SUBJECT: Remarks on RCS Plume Deflector Being  
Considered for LM-5 and Subs - Case 320

DATE: June 6, 1969

FROM: A. S. Haron

MEMORANDUM FOR FILE

FIGURE 1

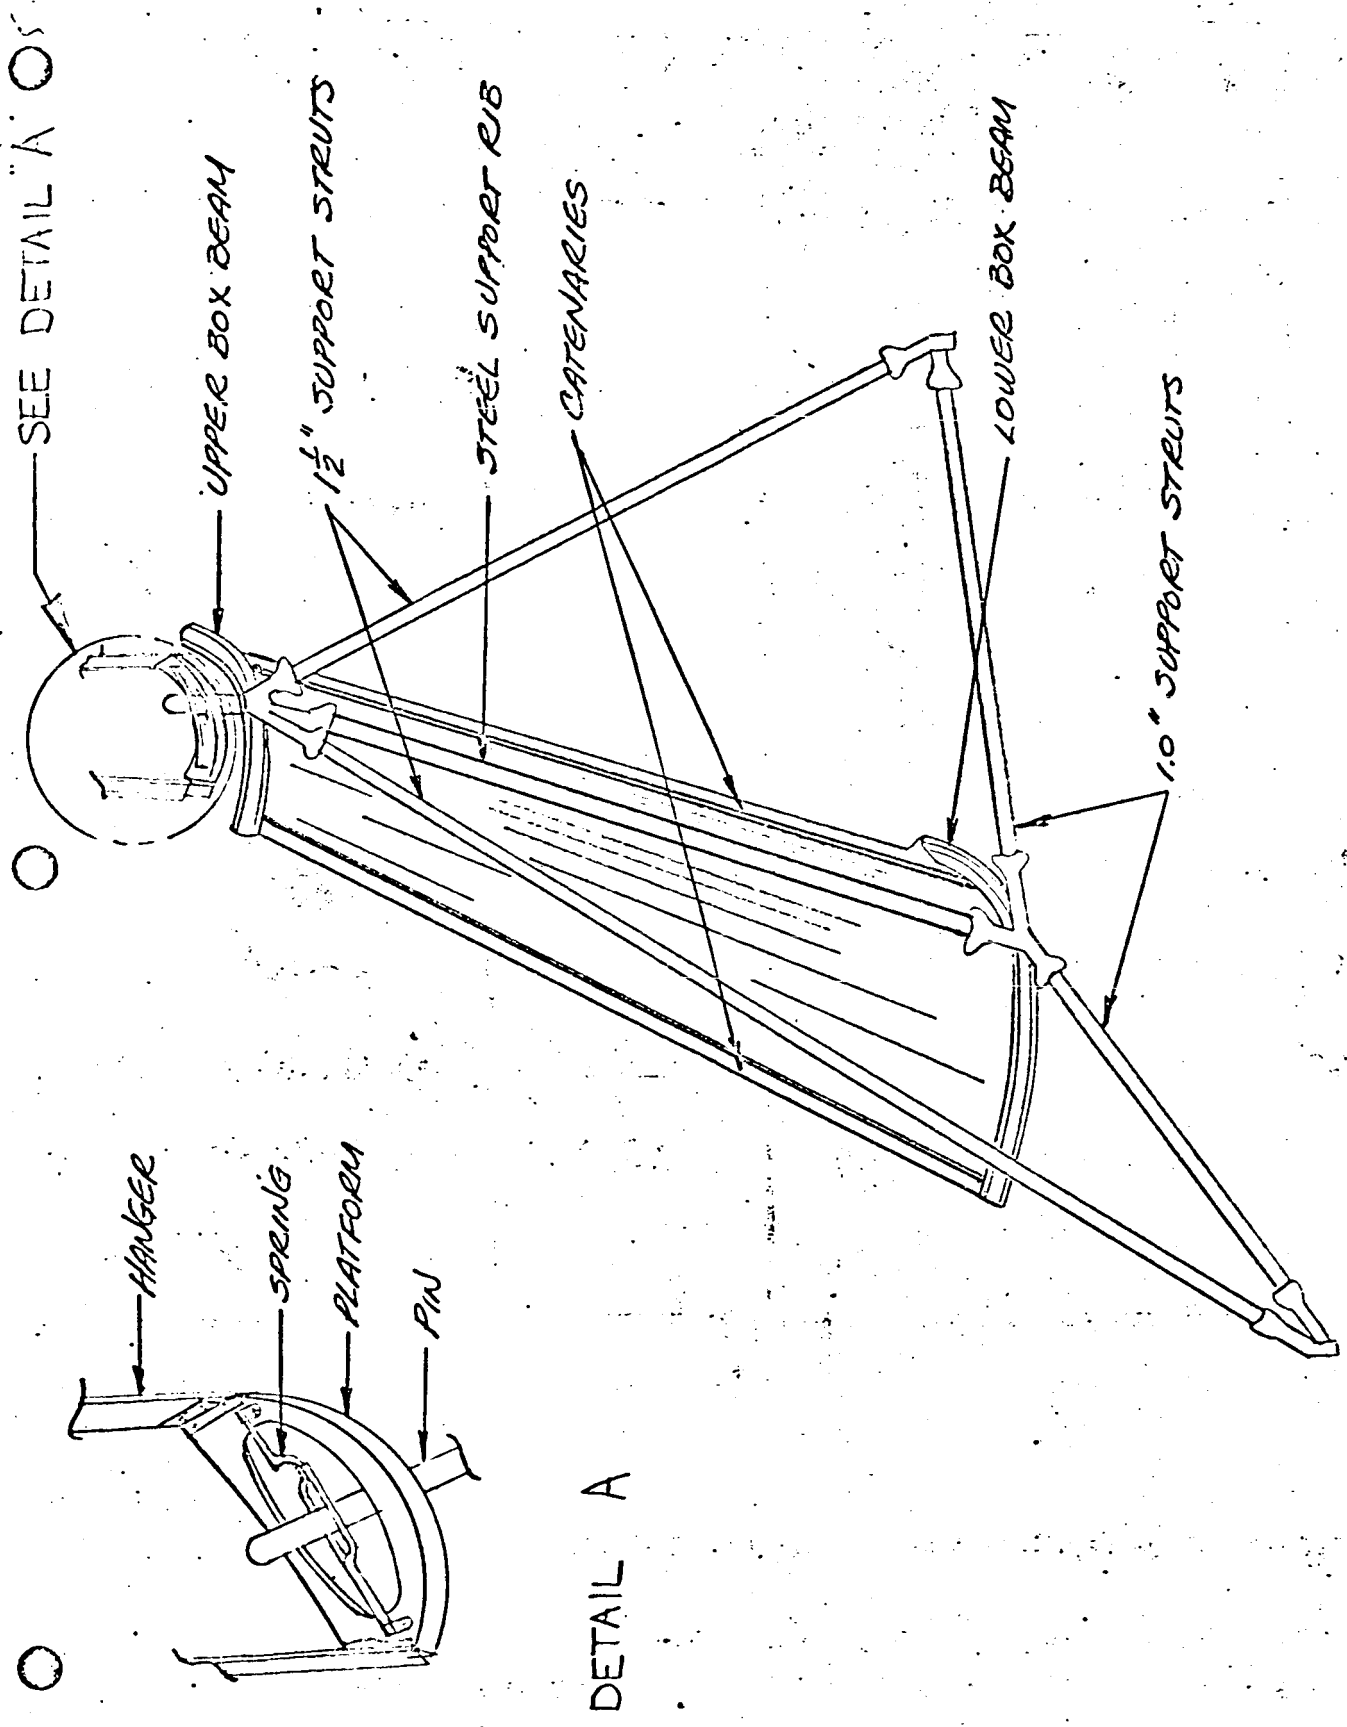
GAEC states that the increase in RCS firing time makes it necessary to install four plume deflectors, one under each downward-firing nozzle. Each deflector (Figure 1) is about 45" long and is configured as a chute encompassing a 47° arc. It is constructed of a laminate consisting of a top layer of 1.25 mil inconel backed by 2 to 6 layers of 0.5 mil nickel, alternately separated by inconel mesh. Each chute is supported by a structural framework mounted on the D/S. The frontface of the chute is coated with black paint ( $\epsilon > 0.8$ ) and the backface is coated with white sicon ( $\epsilon = 0.23$ ). Tests conducted by GAEC indicated maximum temperatures of 1900°F (2300°F allowable) and 700°F (1000°F allowable) for the frontface and backface, respectively. Such deflectors would not only handle the additional heat flux imposed by the revised RCS-firing duty cycle but also permit some lightening of the heat shields of future LM vehicles now being fabricated.

It should be re-emphasized that the installation of RCS-plume deflectors will permit a sizable reduction in the heat shield of future LM vehicles. While schedule impact will not allow reworking the heat shield on LM-5 and LM-6, an earnest attempt should be made to re-configure the heat shield of LM-7 and subsequent vehicles, thus realizing a worthwhile saving in over-all weight (the inert weight of all four deflectors is 32.6 lbs.).
